RE: DA-2279-00 – King Soopers Fuel + Wells Fargo Drive-Thru ATM – Conditional Uses and Site Plan – 1st Comment Responses

Please find below our responses to the first review comments for the King Soopers Fuel + Wells Fargo Drive-Thru ATM – Conditional Uses and Site Plan. To facilitate your review, we have included the original comments in standard font and have provided our responses in ***bold and italics***. Please do not hesitate to contact us should you have any questions or concerns relating to the submittal documents or comment responses.

Private/Engineering Facility Location Sketch

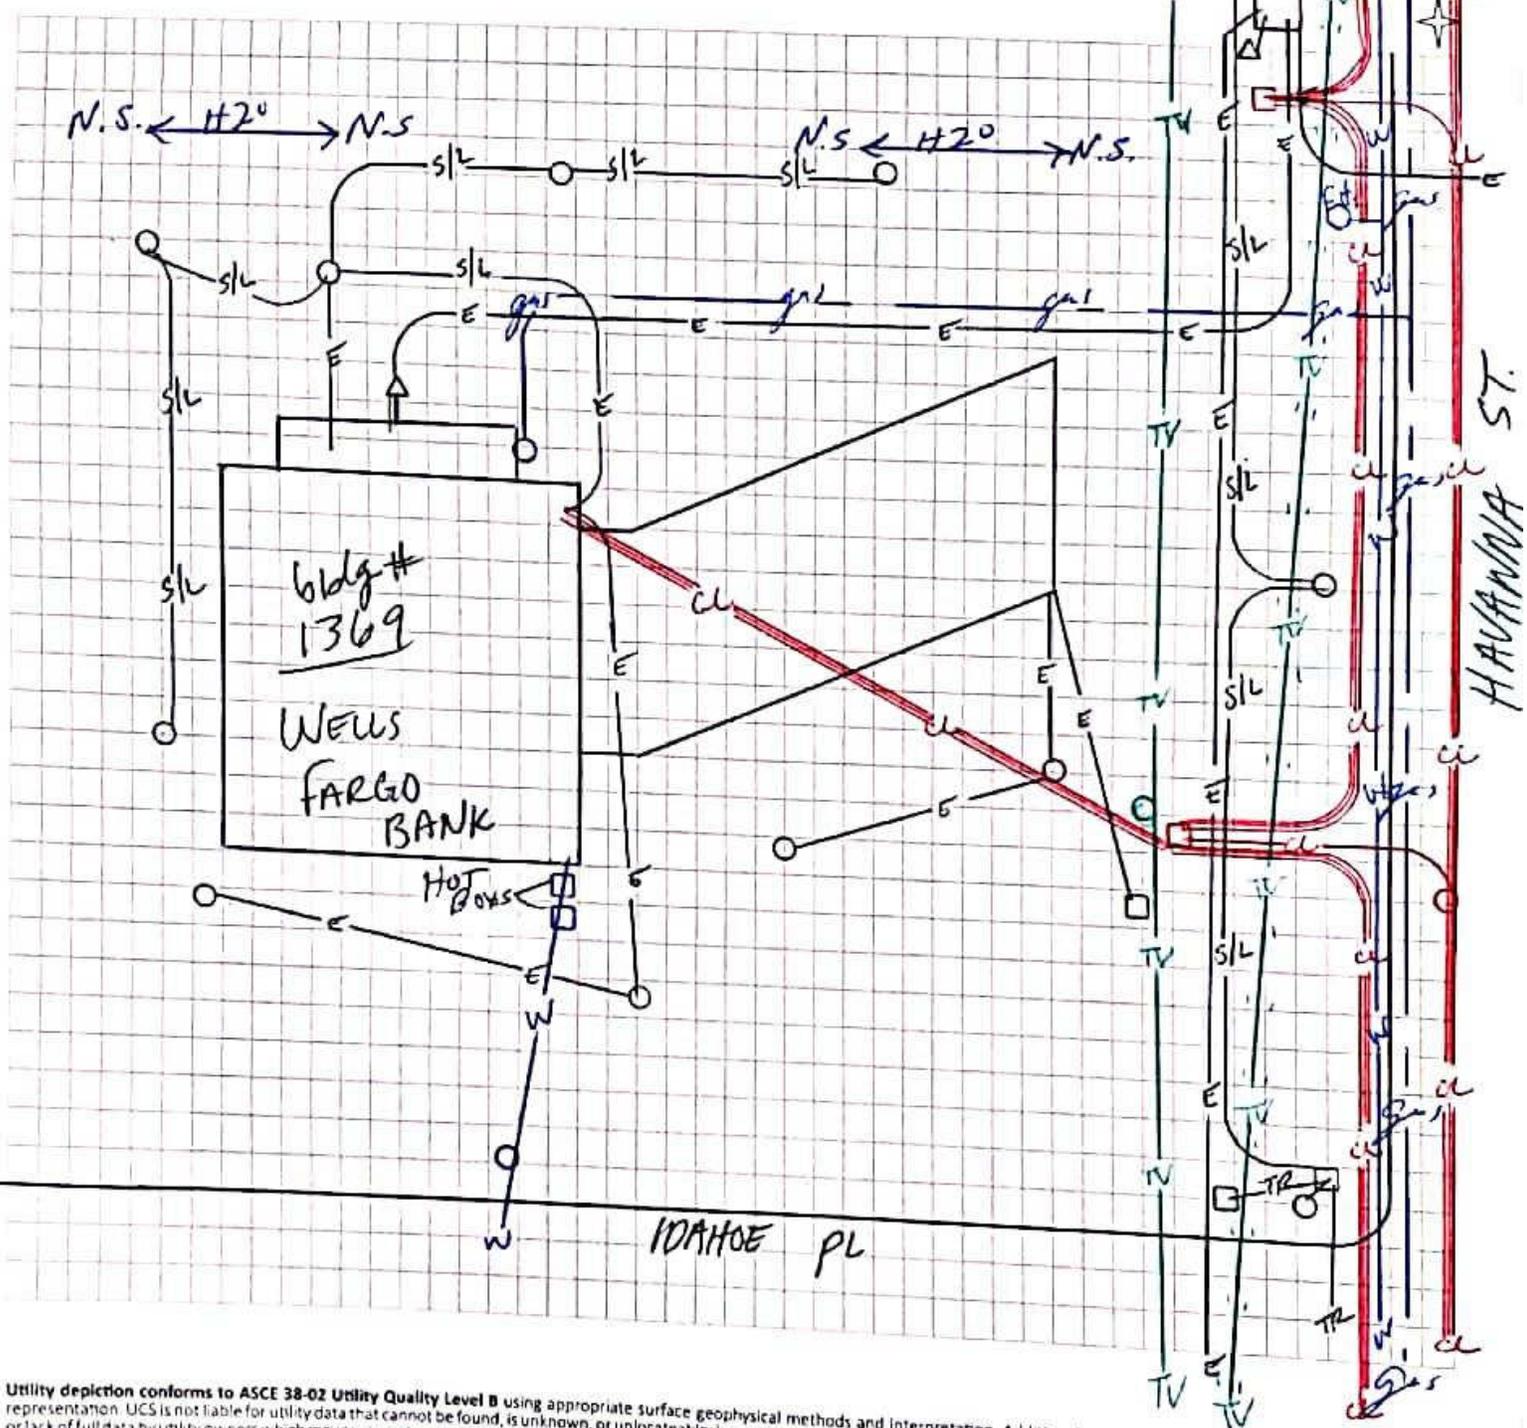
7D. Line to be potholed prior to civil plan approval to determine material type and condition is adequate for public maintenance. As built do not show an additional 3/4 water service for this site.

RESPONSE: Understood. We have included the site sketch provided by the utility locator, which was then paint-marked and surveyed for this project. Please let us know if your records indicate any major discrepancies regarding the existing building's water service.
